CURE Data Response Set 4 (Responses to Data Requests 255 to 287)

Elmore North Geothermal Project (23-AFC-02)

February 21, 2024

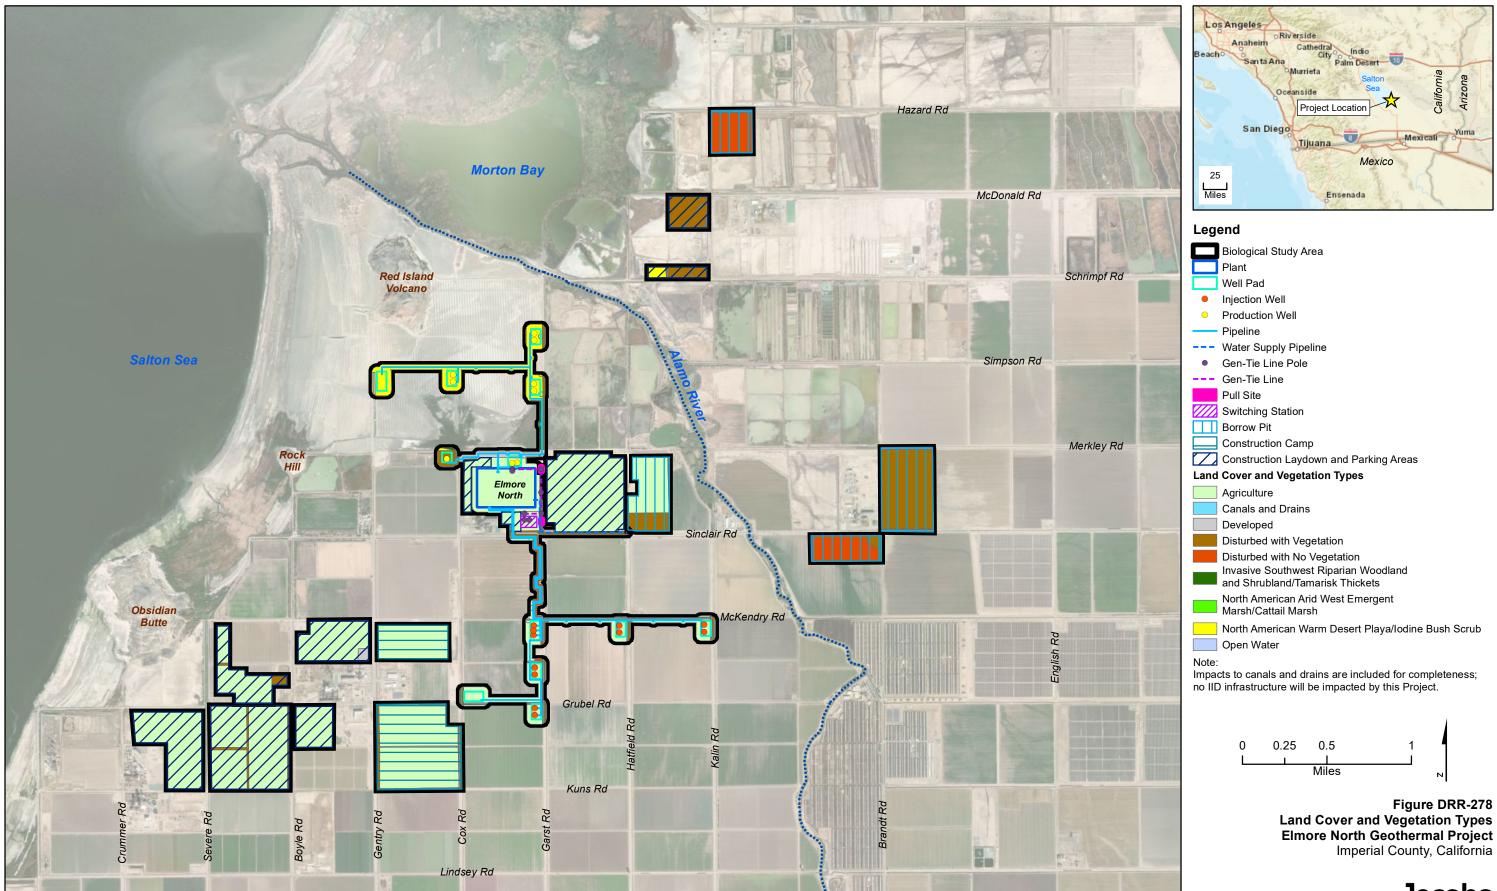
The revised Project boundaries are shown in Figure 1-4R of the Elmore North Geothermal Project Revised General Arrangement Refinement Package. (TN 253187) The Project now proposes a laydown area and an injection well in two locations outside of the BSA, which are depicted within red circles in Figure 1. Information on the land cover types and aquatic resources within the updated Project boundaries has not been provided.

276. State whether biological resource surveys were conducted within the revised Project boundaries in Figure 1-4R that are outside of the BSA boundaries in AFC Figure 5.2-4.

Response: AFC Figure 5.2-1 Biological Study Area, depicts the BSA and project components within the boundaries of the BSA as well as the larger Biological Survey Area. The laydown area and injection wellpads proposed as part of the revised Project boundaries fall within this larger Biological Survey Area and were covered during the biological resource surveys.

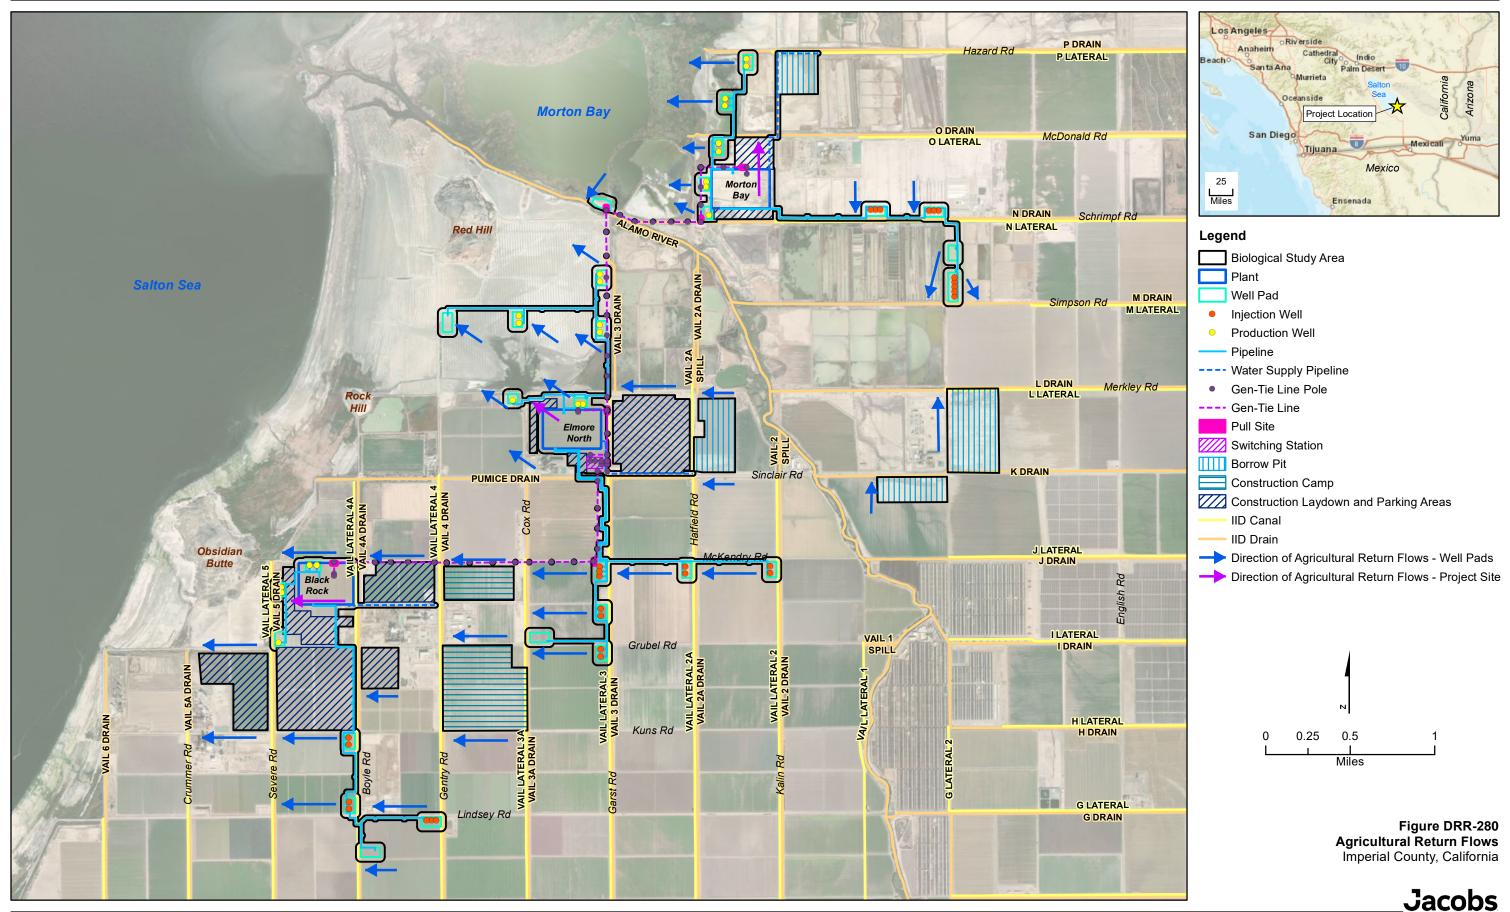
CURE Data Request Set 2 No. 182 asked the Applicant to provide a map that identifies the path of agricultural return flows (irrigation runoff) from the agricultural fields that would be impacted by the Project. In response, Figure DR 182 shows the agricultural return flows from the proposed Project plant site, but not from any of the other agricultural fields that would be impacted by the Project. (TN 254014)

280. Provide maps that identify the path (including receptor drains) of agricultural return flows (irrigation runoff) from all agricultural fields that would impacted (permanently or temporarily) by the Project (i.e., field that will be impacted by the proposed well pads, laydown areas, borrow pits, and construction camp).

Response: Figure DRR-280 identifies all project components along with existing agricultural return flows. Flows from the plant site drain towards Red Hill Bay. Flow directions from all other project components are as shown. Flow direction for the ENGP project site provided in the CURE DR Set 2, Figure DRR 182 has been updated as a result of recent information provided by IID.
